**WHEELING PLAN COMMISSION
THURSDAY, JANUARY 26, 2017 6:30 P.M.**

**AGENDA FOR A REGULAR MEETING OF THE PLAN COMMISSION
to be held in the Board Room of the Village Hall
2 Community Boulevard, Wheeling, Illinois**

REQUEST FOR PLAN COMMISSION ACTION
STAFF PROJECT REVIEW

RE: **Docket Nos. 2016-24A&B and PC 16-18**
(2016-24A) Zoning Variation to Reduce the Parking Setback
(2016-24B) Zoning Variation to Eliminate the Required Screening
(PC 16-18) Site Plan and Appearance Approval of a Parking Lot
300 S. Milwaukee Avenue
Site Plan and Approval for Construction of a Parking Lot

PRIVACY FENCE
SCALE: 1/4"=1'-0"

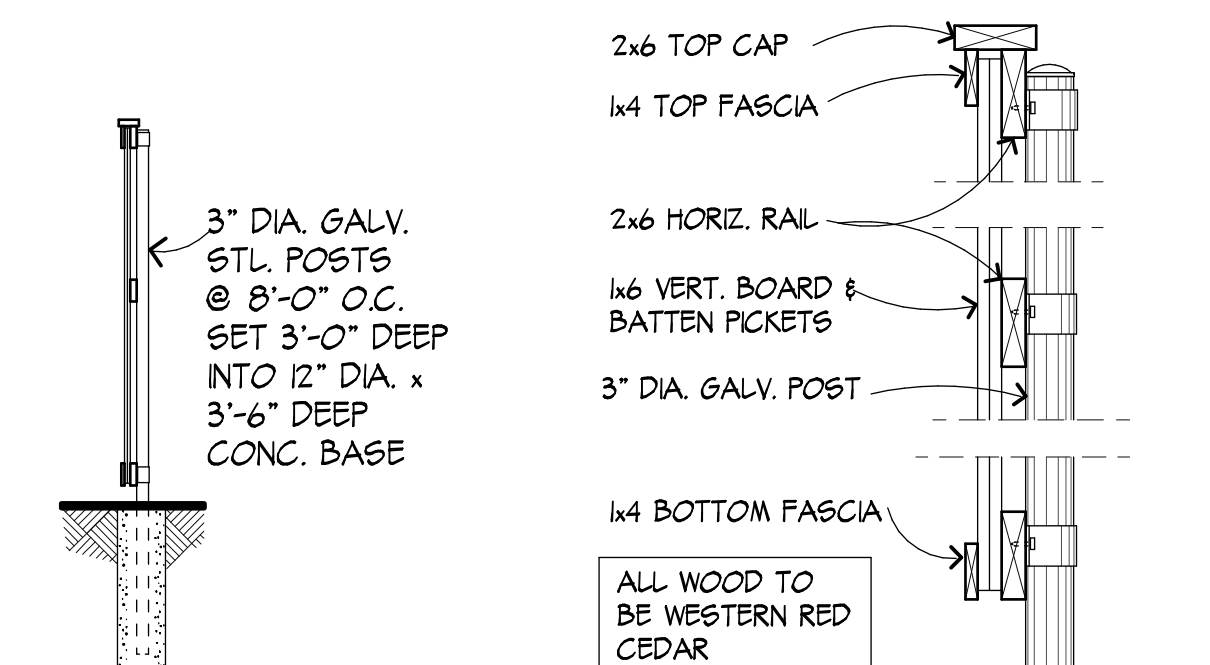
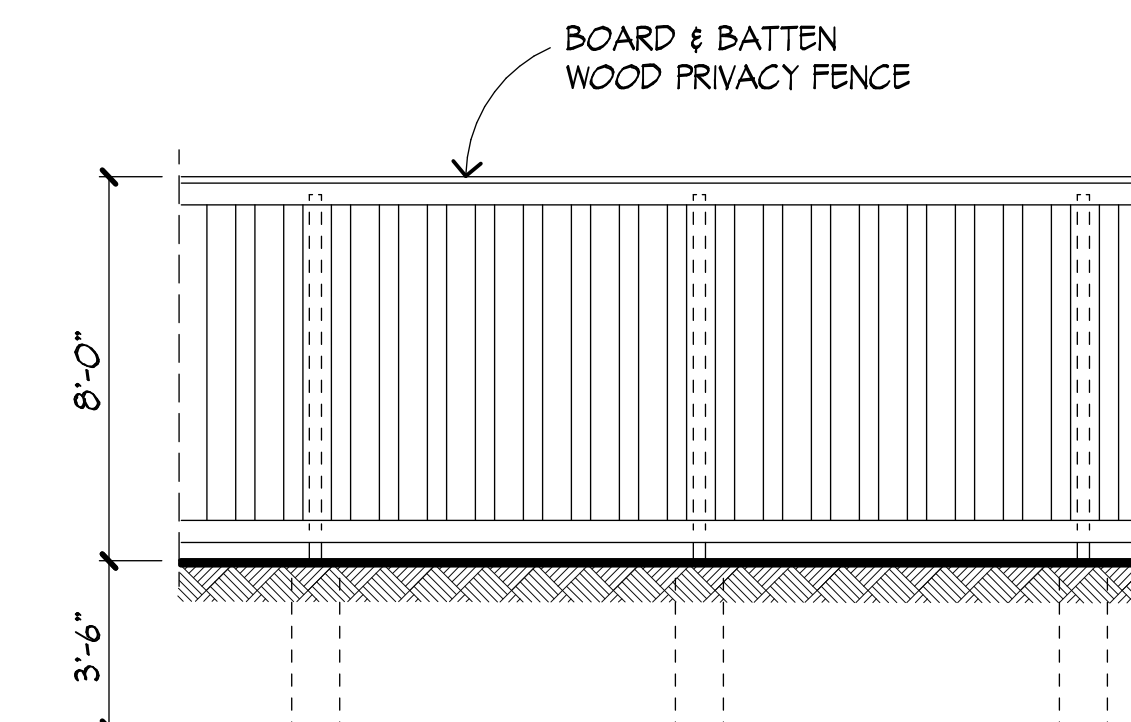
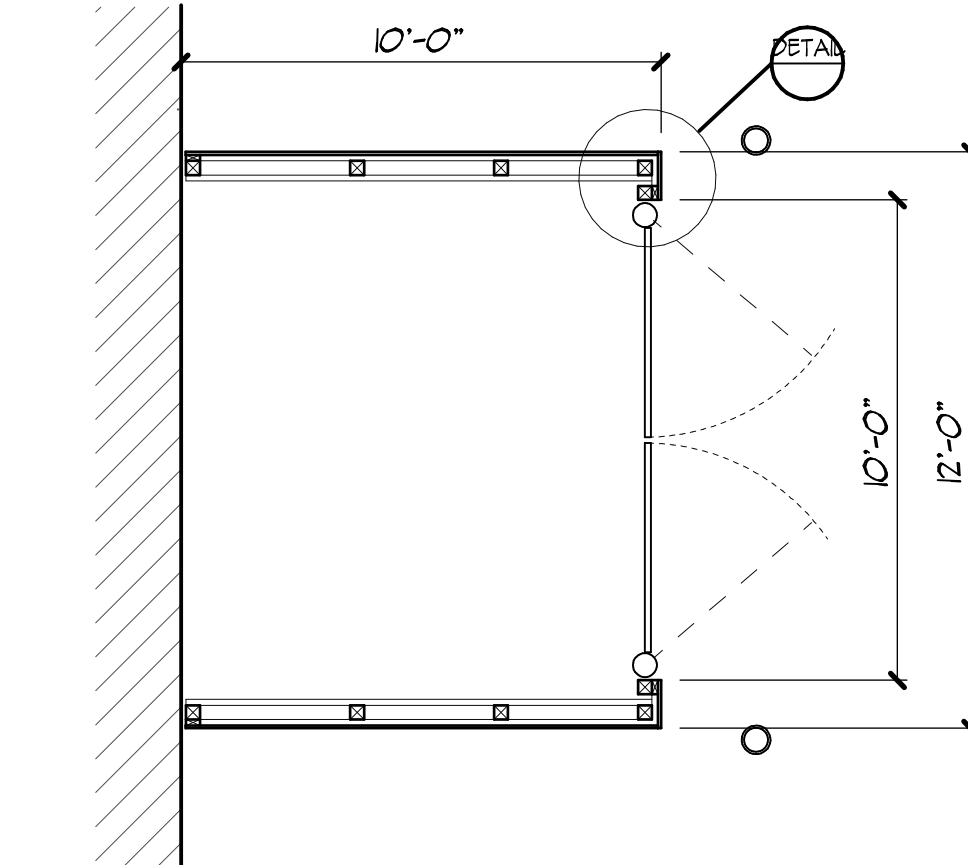
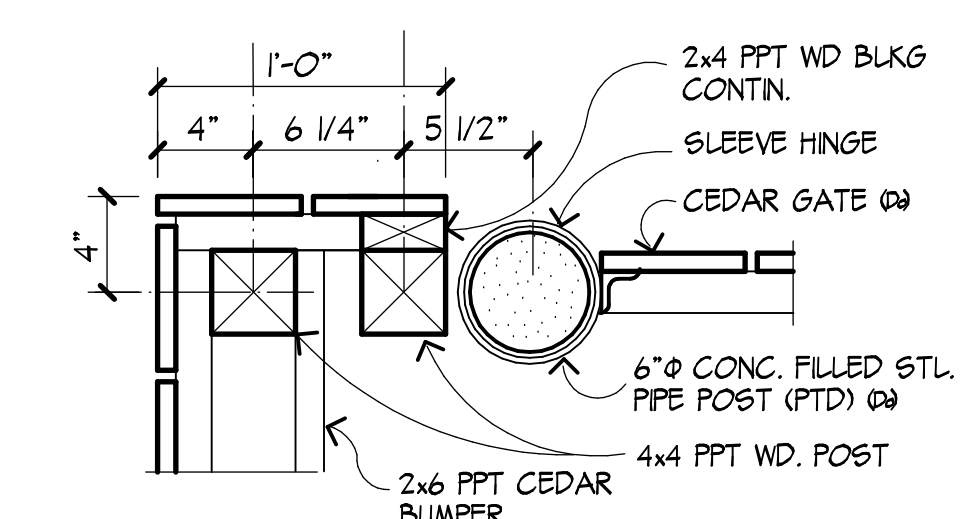
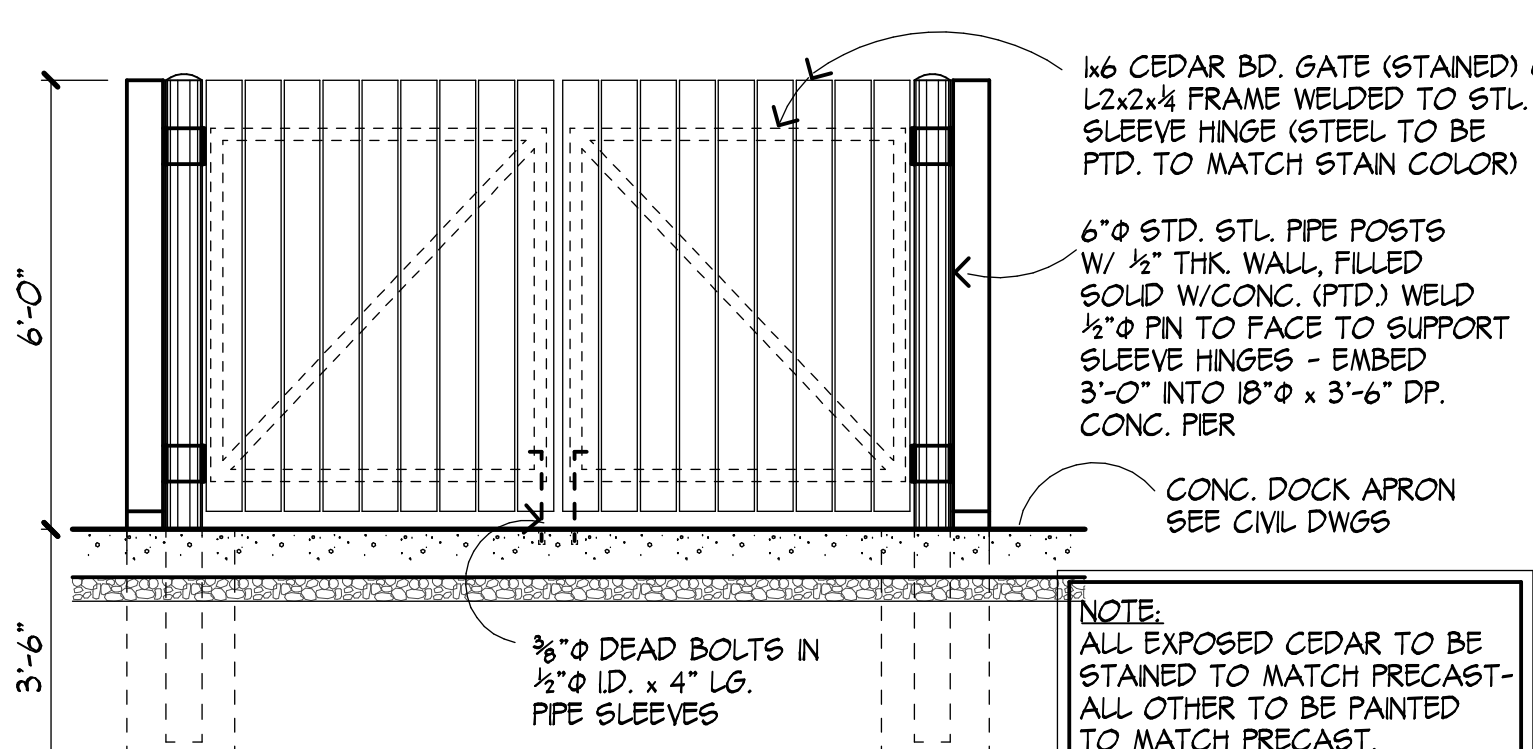
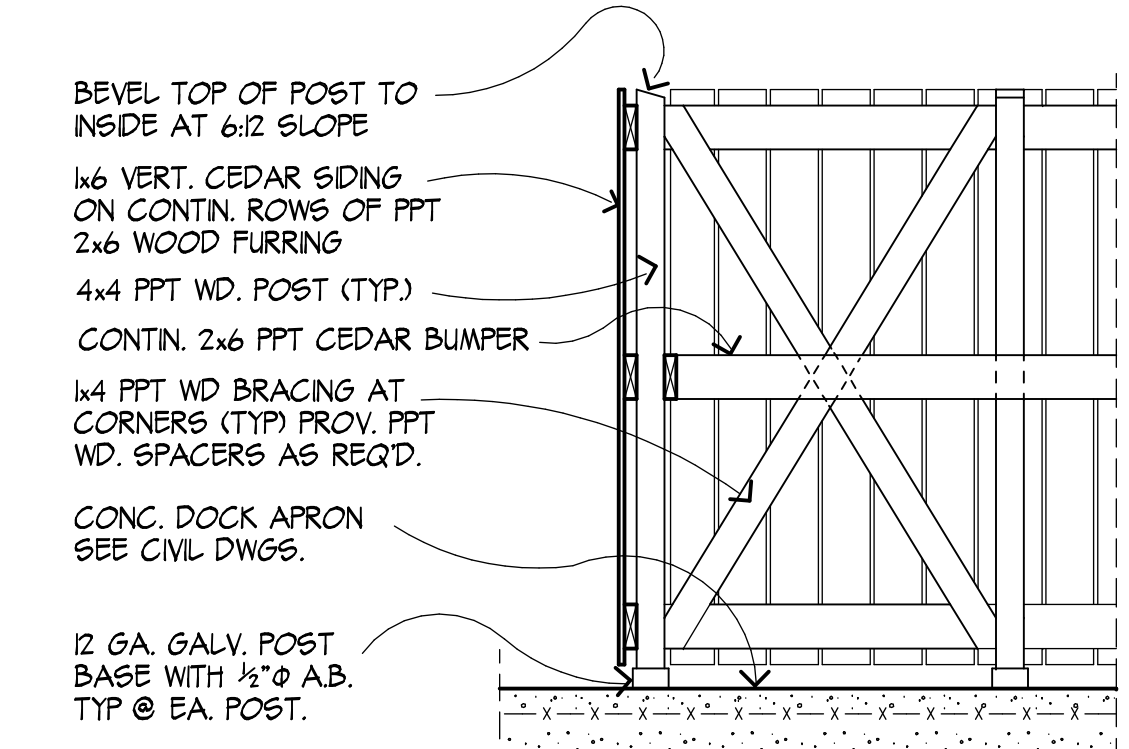
Fencing: Along the rear (east) property line, which abuts Wolf Run Estates, an 8-foot high solid wood privacy fence is proposed. An elevation and section plan of the fence is provided on the site plan. Photographs to demonstrate the fence appearance are also provided.
